## RESPONSE TO REQUEST FOR ADDITIONAL INFORMATION

### APR1400 Design Certification

RAI No.: 461-8579

SRP Section: 15.06.03 - Radiological Consequences of Steam Generator Tube Failure (PWR)

Figure 1 Primary and Secondary Pressures vs. Time

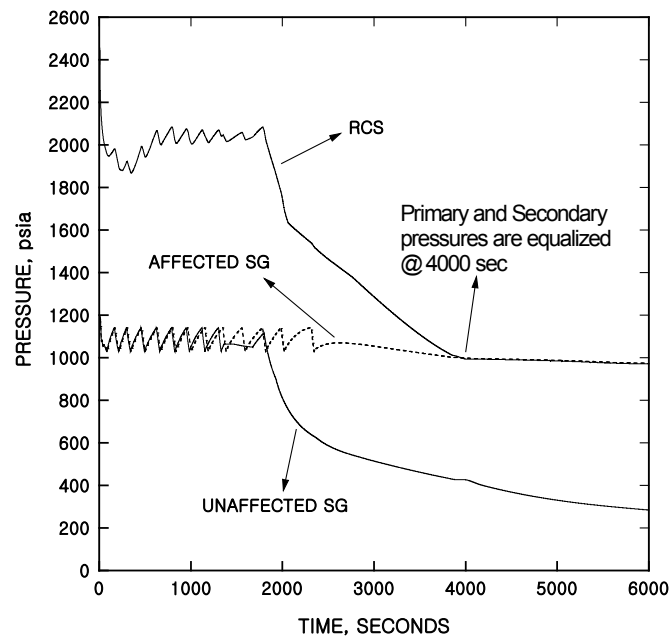
2. The RAI response contained information that appears to contradict information contained in the APR1400 DCD. Particularly, the RAI response states, "The analysis in the DCD conservatively assumed that the break flow rate at 30 minutes is maintained until the time at which the primary and secondary pressure are same, or the break flow is terminated." However, Table 15.6.3-5 of the APR1400 DCD shows that steam mass relief from the affected steam generator is 0.0 beyond 30 minutes (i.e. steam relief through the affected steam generator is terminated immediately upon initiation of operator action).

1. Extend the CESEC-III analysis of the SGTR event until acceptable analysis termination criteria are met (e.g. steam relief through affected steam generator is terminated, break flow is terminated)
2. Update Section 15.6.3 of the APR1400 DCD as appropriate.
3. Update the analysis of radiological consequences as appropriate.

As shown in the Figure 1 below, the primary and secondary pressures are same at 4,000 seconds after the event initiation. The break flow is decreased after 1,800 seconds and terminated at 4,000 seconds as shown in Figure 2. However, in terms of radiological consequences, the results in DCD conservatively assumed that the break flow rate at 1,800 seconds is maintained until that the primary and secondary pressures are equalized in the calculation of the flashed mass of break flow. The total flashed mass of break flow is assumed to be completely discharged to the environment. Therefore, DCD analysis presents a bounding case in terms of radiological consequences.
